TECHNICAL SERVICE BULLETIN

ISSUE DATE:	10/11/2021
SERVICE BULLETIN SUBJECT:	ZX5 BTMS Mounting Strap Bracket Retrofit
VINs or MODELS AFFECTED:	Service Specified Buses
COMPLETE BY:	Next Service Opportunity
SERVICE BULLETIN #:	SC-21-143
LABOR OPERATION CODE:	N/A

ZXF BTMS MOUNTING STRAP BRACKET RETROFIT

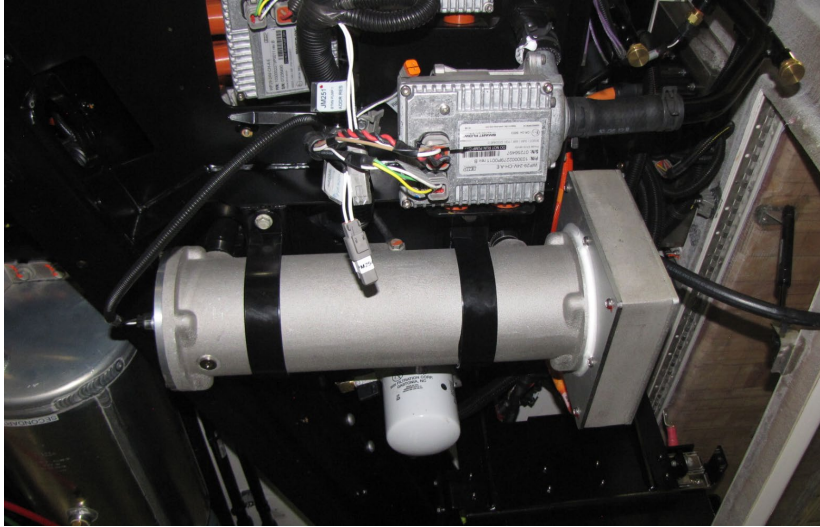
The procedure updates the battery heater mounting straps to a more robust version.

- 059593 RETROFIT KIT, BRACKET STRAPS, BTMS (Consisting of)
 - 125-5960 BRACKET, STRAP 2 EA
